# Access Compliance Report

## Public Rights-of-Way

### (Pedestrian Signals)

Intersection ID: N/A	Main Street:	Cross Street: N/A	Location: N/A
ADA ID: 9754105D6013	Signal Type: One Push Button-Non APS	Overall Compliance: No	Severity Score: BTN 1: N/A BTN 2: N/A No BTN: N/A
Codes/Mitigation Info/Possible Solution		Field Measurements/Component Compliance

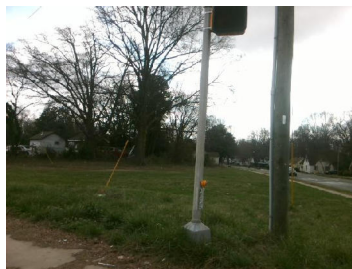
PROW/ADA: TMUTCD 4e.08, R404.2, R404.3, R404.7.2

N/A	B 1 Clear Xing Direction?	Yes	N/A	B 2 Clear Xing Direction?	N/A
	B 1 Crossing Direction	To NE		B 2 Crossing Direction	N/A
Yes	B 1 DistanceTo XWalk (in)	35.0	N/A	B 2 DistanceTo XWalk (in)	N/A
No	B 1 DistanceTo Curb (in)	118.0	N/A	B 2 DistanceTo Curb (in)	N/A
Yes	B 1 Diameter (in)	2.0	N/A	B 2 Diameter (in)	N/A

Possible Solutions: Replace Signal Push Button With APS Button on New Post. Remove & Relocate Sign.
